UNITED STATES PATENT AND TRADEMARK OFFICE

APPLICATION NO.	FILING DATE	FIRST NAMED INVENTOR	ATTORNEY DOCKET NO.	CONFIRMATION NO.
09/878,325	06/12/2001	Tsuyoshi Kitahara	Q64826	2121

Office Action Summary

DETAILED ACTION

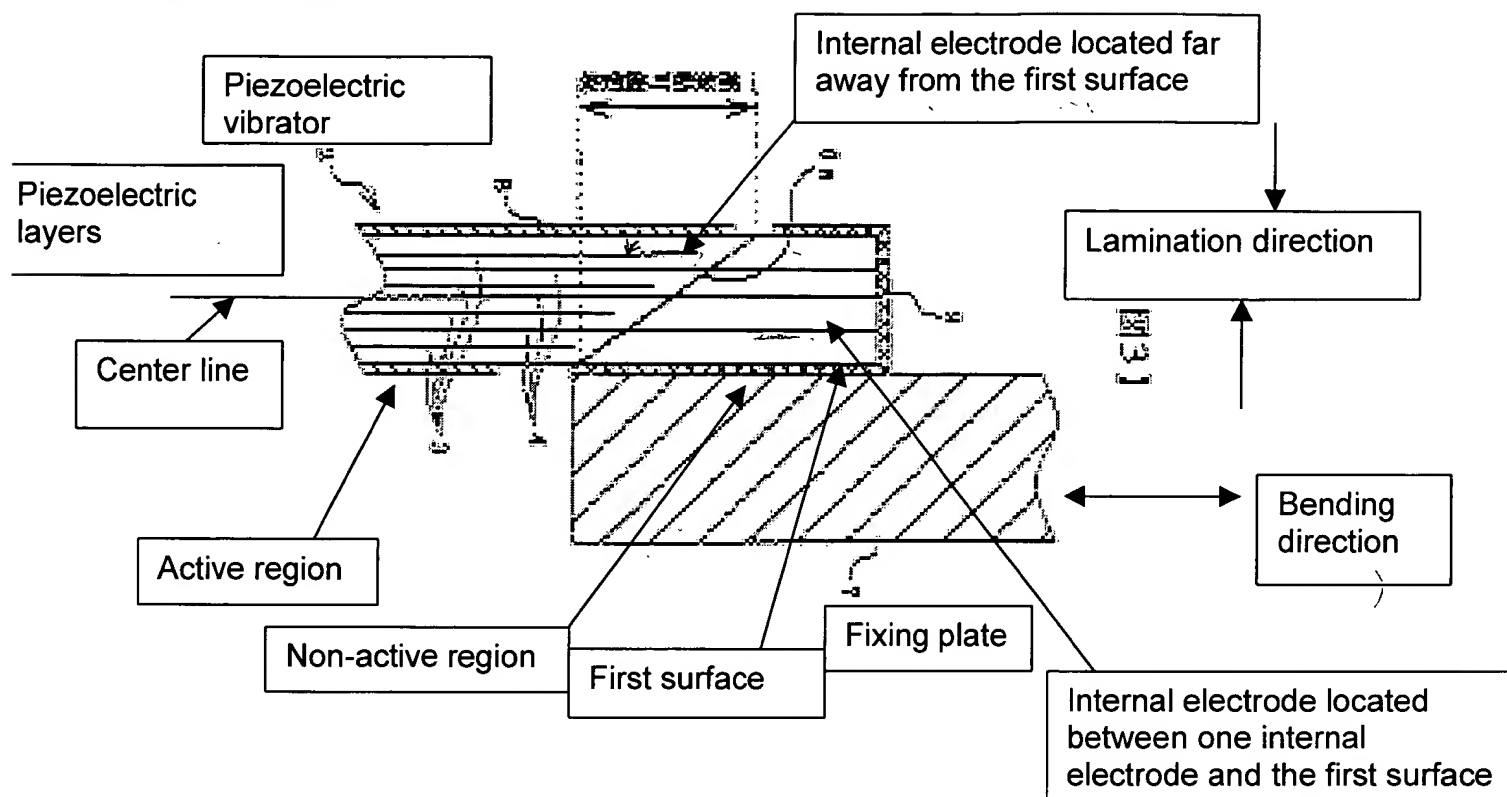
- Common internal electrode layers (Fig.3: element 4) and segment internal electrode layers arranged alternately (Fig.3: element 3)
- Piezoelectric layers, each interposed between adjacent pair of the common and segment internal electrode layers (Fig.3)
- External electrodes formed on an exterior of the piezoelectric vibrator and electrically connected respectively to the common internal electrode layers and the segment internal electrode layers (Fig.3: element 9)
- A fixing member to which a surface of the piezoelectric vibrator is fixed (Fig.3: element 7)

- The piezoelectric vibrator is displaceable in a direction perpendicular to a lamination direction in which the internal electrode layers and piezoelectric layer are laminated (Fig.3)
- A length of at least one of the internal electrode layer, located away from the surface fixed to the fixing member is shorter than other internal electrode layers located between the at least one internal layer and the first surface (Fig.3)

With respect to claim 17, Kitahara discloses the piezoelectric vibrator further includes a non-active portion that is not expanded or contracted even when the piezoelectric layers in an active region are driven and the fixing member is joined to a side surface of the non-active portion (Fig.3).

3. Applicant's arguments filed 8/22/02 have been fully considered but they are not persuasive.
- Applicant's argument that Kitahara does not teach a length of at least one of the internal electrode layer, located away from the surface fixed to the fixing member is shorter than other internal electrode layers located between the at least one internal layer and the first surface is not persuasive because refer to figure 3, the internal electrode layer located far away from the first surface is short than the internal electrode layer located between the at least one internal electrode layer and the first surface. Therefore, Kitahara meets the limitation of the claim.
